DEVELOPMENT SERVICES COUNCIL REPORT

File No: DP 22-26

Subject: **DP 22-26; Development Permit with Variances; 3401 Sundance Drive**

Figure 11: Setback variance for Sundance Units (1-20) – example of Building 1, units 1-4.

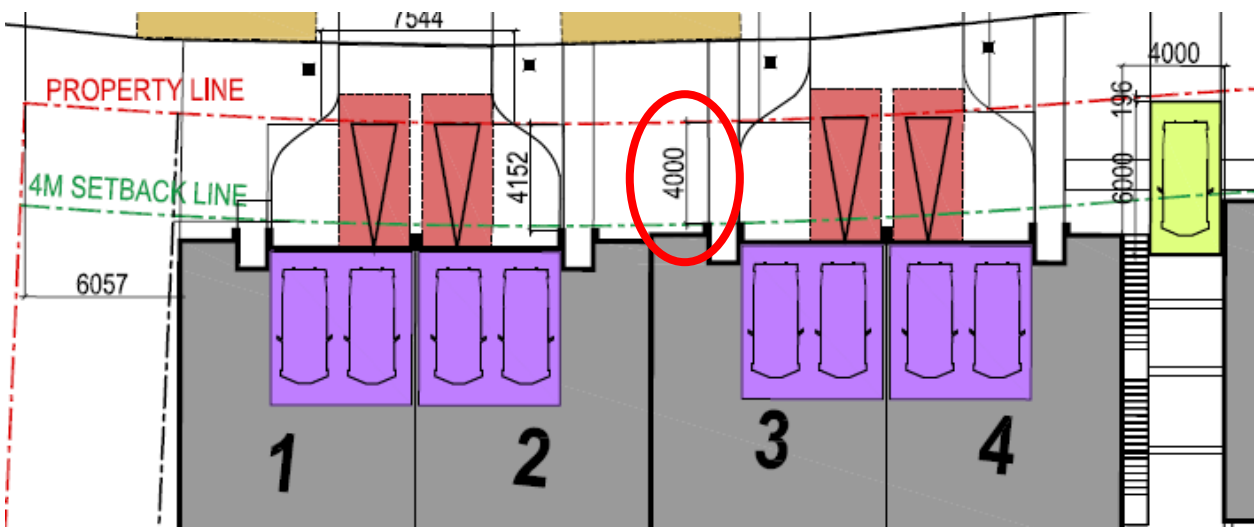
1. S.10.11.4(g)(i) – Reduce the minimum required front parcel boundary setback (Sundance Drive) from 6.0 m to 4.0 m (varies), in accordance with the site plan (Attachment 2, Figure 1 and 11). This variance affects all five buildings located on Sundance Drive. Recent amendments to the Bylaw allowing for setback measurements to be taken from the back of a curb or sidewalk were not added to the R4 Zone.

Since the Sundance Drive Right of Way will accommodate 3-4 metres of driveway from the curb to the property line, plus the additional 4 m setback (minimum) from

the property line to the buildings, vehicle overhang into the physical roadway is not anticipated. Staff support this variance.

Figure 14: Loading space dimensions.

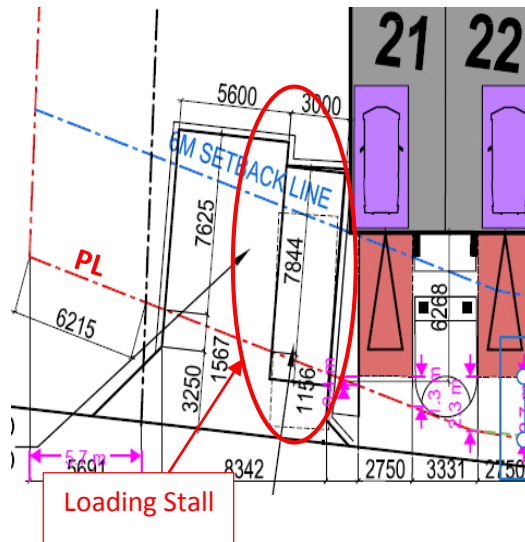
4. S.4.10.2(a) – Reduce the minimum required dimensions of a loading space from 3.0 m x 9.0 m to 7.8 m x 3.0 m (Attachment 2, Figure 14).

Related to Variance No. 3 above, the single loading space proposed on Ensign Quay Lane cannot be adequately accommodated on the subject property (Figure 14).

The construction of the loading space must also occur within the easement boundary contained on the adjacent property. The access easement permits maintenance of the physical laneway. The easement boundary also widens at this point of the laneway, so vehicles using the loading space are not anticipated to obstruct the pass or repass of vehicles. Staff support the proposed variance.

Figure 15: Over-height retaining walls (2)

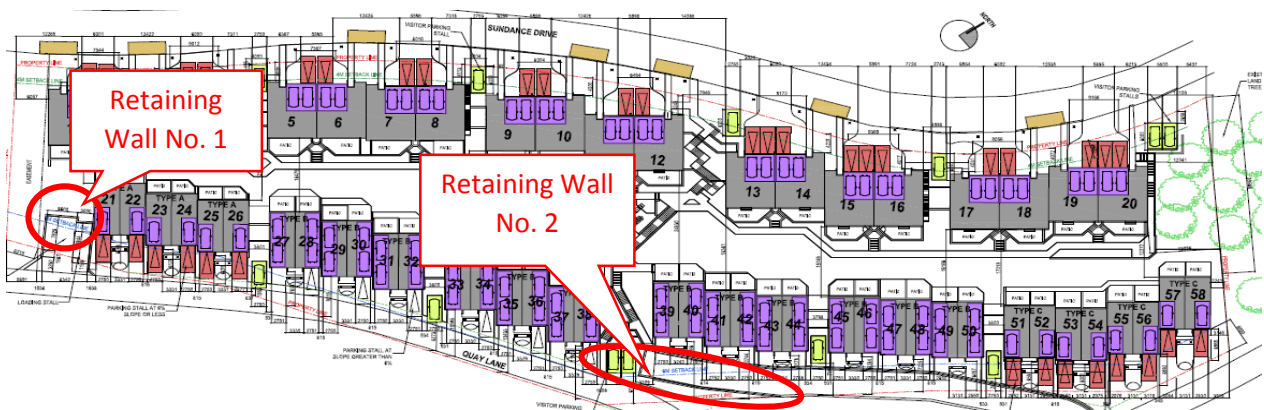
5. S.3.14.1 – Increase the maximum height of two retaining walls from 2.5 m to 3.5 m (Figures 15-18).

The proposal includes two over-height retaining walls up to a maximum 3.5 m. The first retaining wall (Figure 15) is proposed to accommodate the emergency turnaround at the terminus of Ensign Quay Lane. Staff are supportive of this variance, given the challenging topography of the site, the critical purpose of the turnaround, and the limited impacts to adjacent properties.

Figure 16: Over-height retaining wall No. 2.

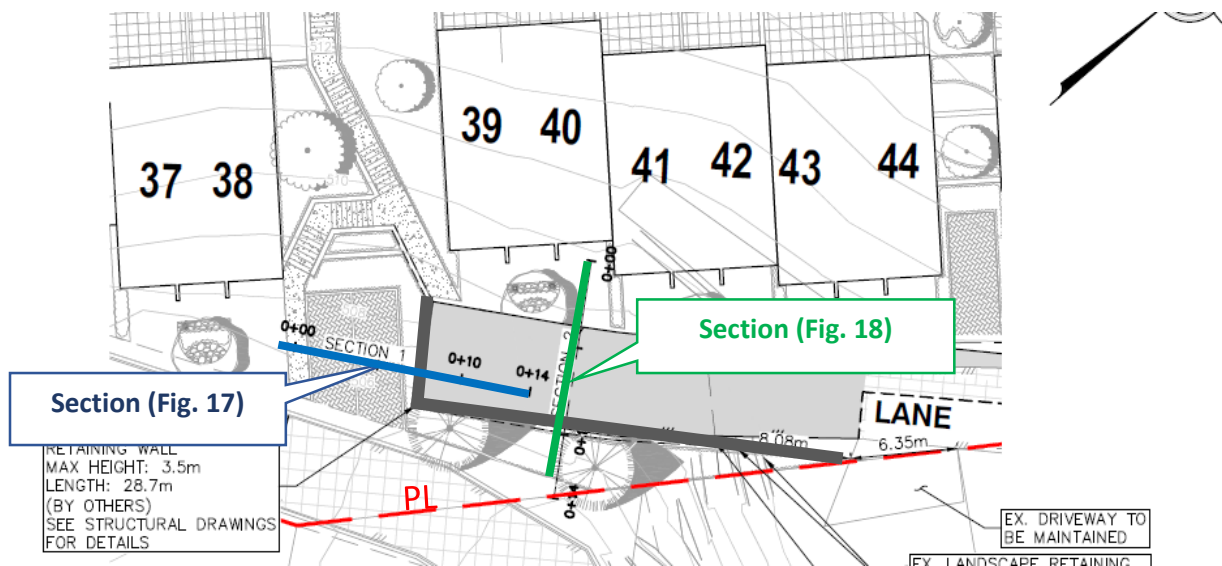
The second over-height retaining wall (Figure 15-18) is proposed to extend the existing physical laneway on Ensign Lane to accommodate vehicle access/egress to units 39-44, as the existing site topography is steep at this location. The wall is

proposed to be located adjacent to the easement boundary but not encroach within it or the adjacent property.

Staff have do not have concerns with the height of the wall, but do have concerns due to its location and the proximity of the extended portion of laneway to the units near its terminus as it relates to on-site circulation and safety. Proposed units 39 and 40 are likely to encounter challenges with egress from their tandem garages given the minimal space available for turning. Where turning is possible, the wall results in an immediate 3.5 m drop in elevation to surrounding steep slopes and visitor parking spaces. Winter conditions and snow storage at the terminus of the lane is also likely to further exacerbate this hazard.

Staff are recommending that Council direct the applicant to revise the design of the extended portion of Ensign Lane to include increased safety elements consistent with best practices and the City's Hillside DPA guidelines and demonstrate that turning movements can be reasonably accommodated to any units near its terminus.

Figure 19: variance to the width of driveway crossings (4 of 8 crossing over 7.0 m shown here).

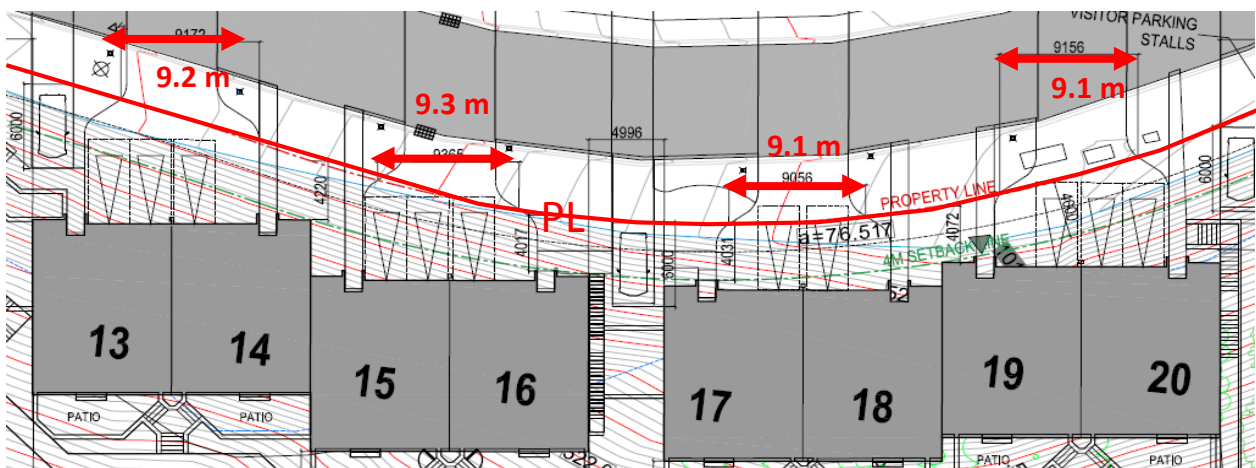
6. S.4.4.3(ii)(b) – Increase the width of driveway crossings at the property line (Sundance Drive) from a maximum 7.0 m to 9.4 m (varies), in accordance with the site plan (Attachment 2, Figure 19).

A variance to the maximum width of driveway crossings is to accommodate double driveways for the units on Sundance Drive. This variance applies to eight of 10 paired driveway crossings. Staff do not anticipate impacts from the paired driveways and support the variance.

Figure 20: Variance to forgo turnaround on Ensign Lane

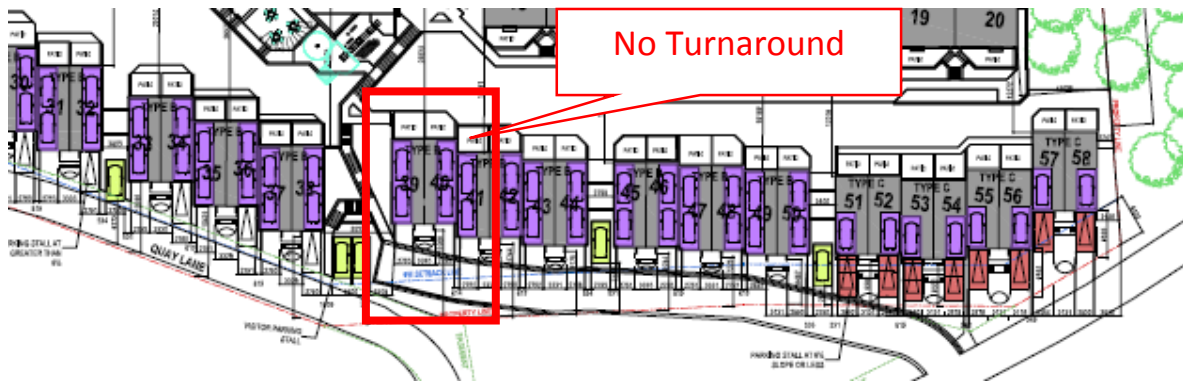
7. S.8.2.2: To forgo the requirement to install a turnaround at or near the terminus of private hillside lane (Figure 20).

The City's Works and Services Bylaw requires private hillside lanes to include a turnaround at or near their terminus. This is for the purpose of improving vehicular

circulation, particularly with emergency or service vehicles (snow clearing, delivery, waste management). In the absence of a turnaround, it is anticipated that larger vehicles would need to turnaround on private driveways or reverse in or out of the laneway. This variance applies to Ensign Lane only, as a turnaround is proposed on Ensign Quay Lane.

Although the City's Fire Department has confirmed they do not oppose the variance, the City's Engineering Department has stated that the turnaround is important for vehicle circulation and safety. In the absence of a turnaround, service and emergency vehicles would potentially be obstructed or obstruct the laneway. Passenger vehicles are also anticipated to have challenges turning around, given that the laneway contains only two visitor spaces and short driveway apron depths for units 39-50. Also, units 51-58 include only single garages; while consistent with the Zoning Bylaw regulations for off-street parking, including required parking in front of the garages adjacent to the laneway may exacerbate anticipated access and circulation challenges.

- Include a turnaround and loading space on Ensign Lane;
- Secure legal access for units 53-56 (approx.) on Ensign Lane;
